UNION STUDIO
ARCHITECTURE & COMMUNITY DESIGN

ADDENDUM

ADDENDUM NO.: 2
DATE: 06/24/16
PROJECT: CHW | ChurchWoods
PROJECT ADDRESS: 4130 Old Post Road
Charlestown, RI

OVERALL LANDSCAPE PLAN

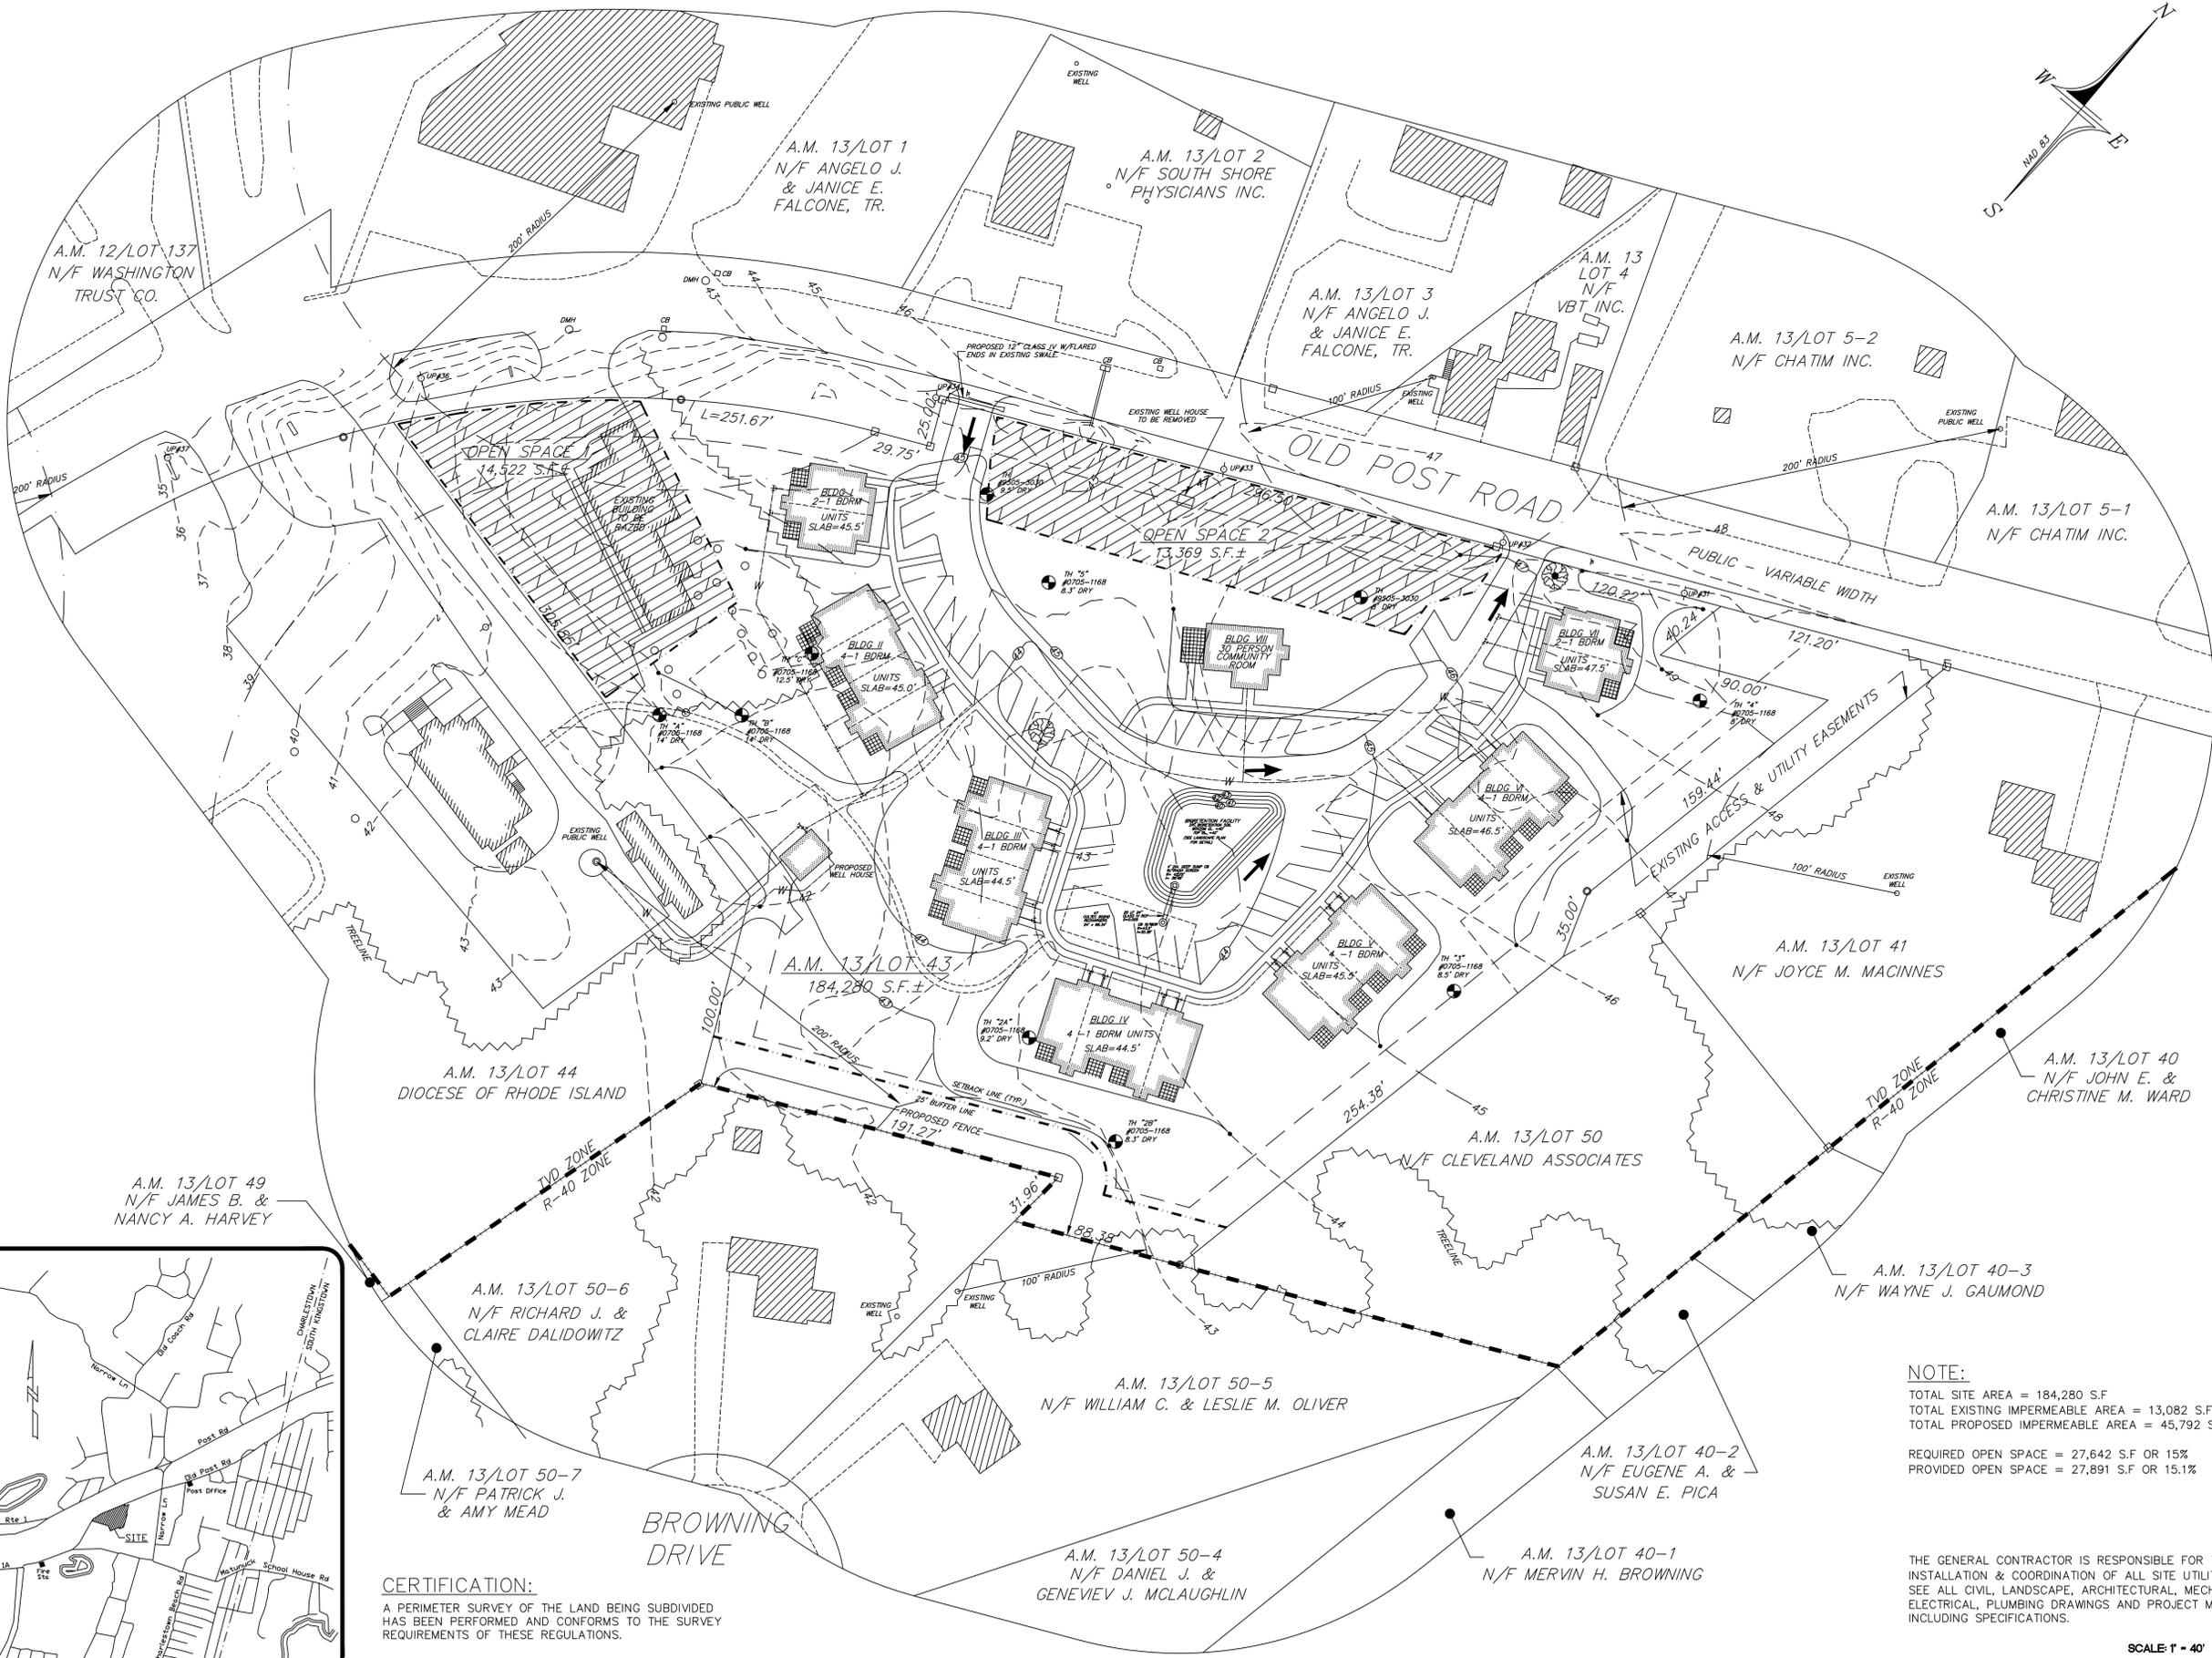
23. Clarification:
L.101 Overall Landscape Plan, dated May 27, 2016 at **1:30 scale** (which shows full extents of the site plan and property) will replace L.101 Overall Landscape Plan, dated May 27, 2016 at **1:20 scale**. See attached.

CHURCHWOODS
4130 OLD POST ROAD
CHARLESTOWN, RI
SYSTEM LAYOUT

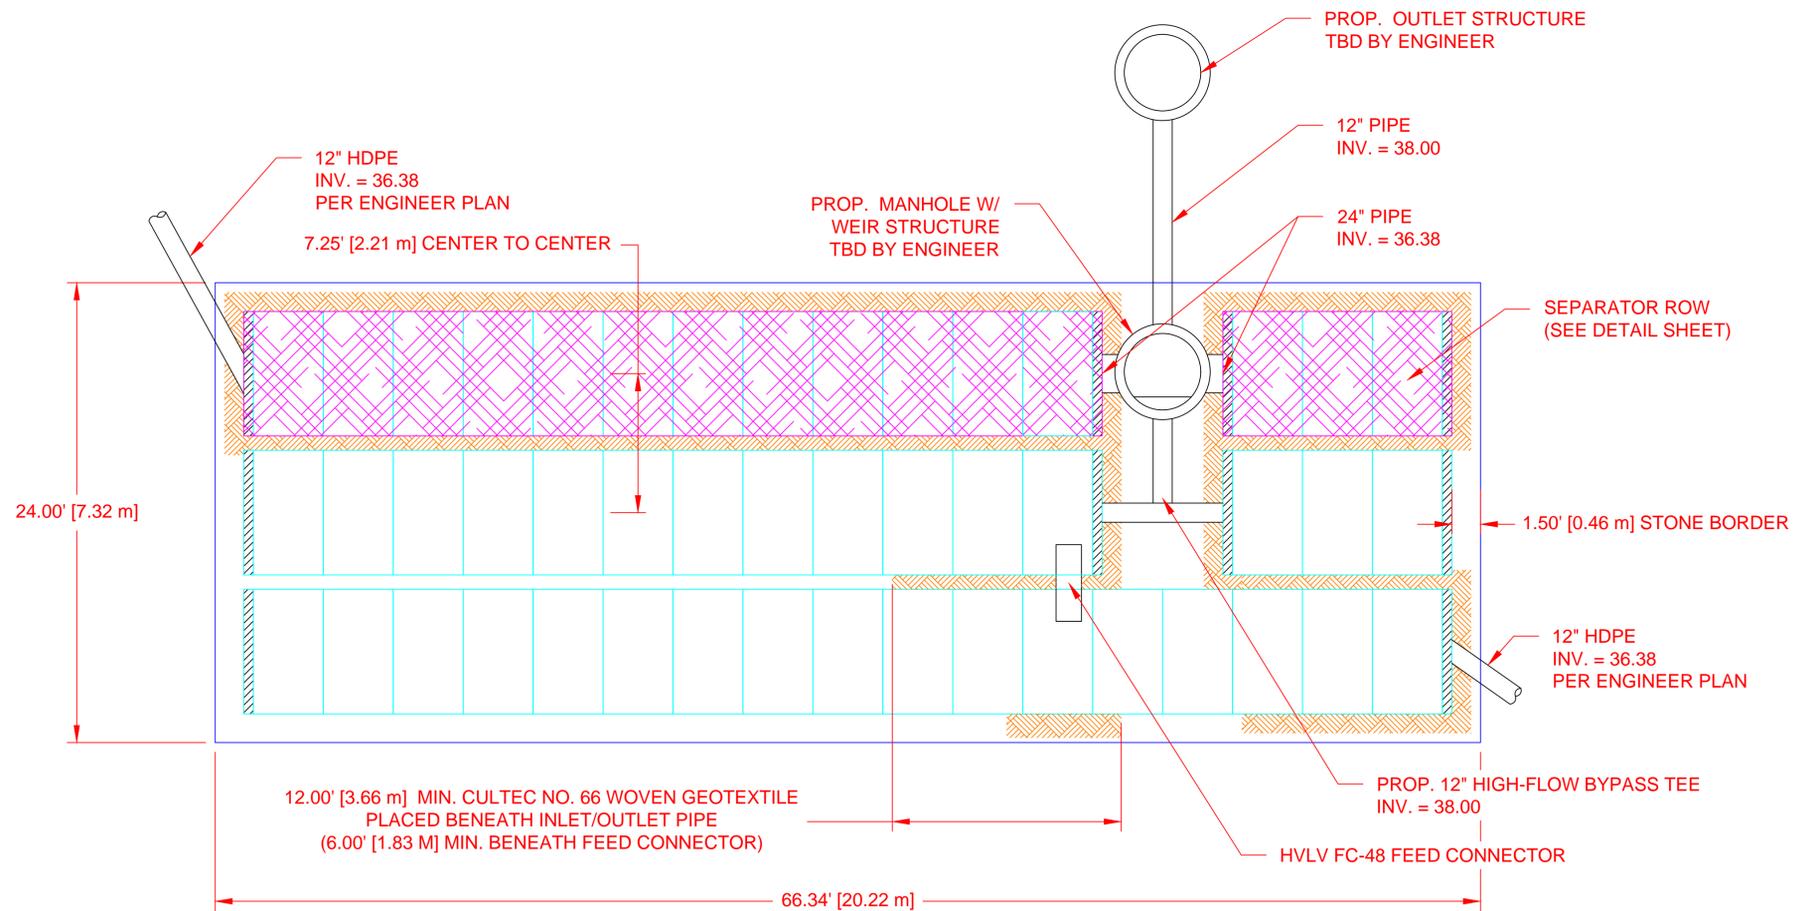
9. Question: Sheet 3 C-4 calls for a "CB W/Weir" to be installed in the Cultec Recharger system, provide more detail as to how the "CB W/Weir" is connected to the Cultec Recharge System.

Answer: Attached are the final drawings/computations from the manufacturer Cultec that have been approved by RIDEM and RICRMC. The drainage structure on drawing C4 labelled CB w/weir can be another 4' diameter deep sump catch basin as shown on Sheet C6 (MADEP 2008) with a 24" outlet to the separator row (at the inverts given on the Cultec drawings) set lower than the 12" high flow by-pass.
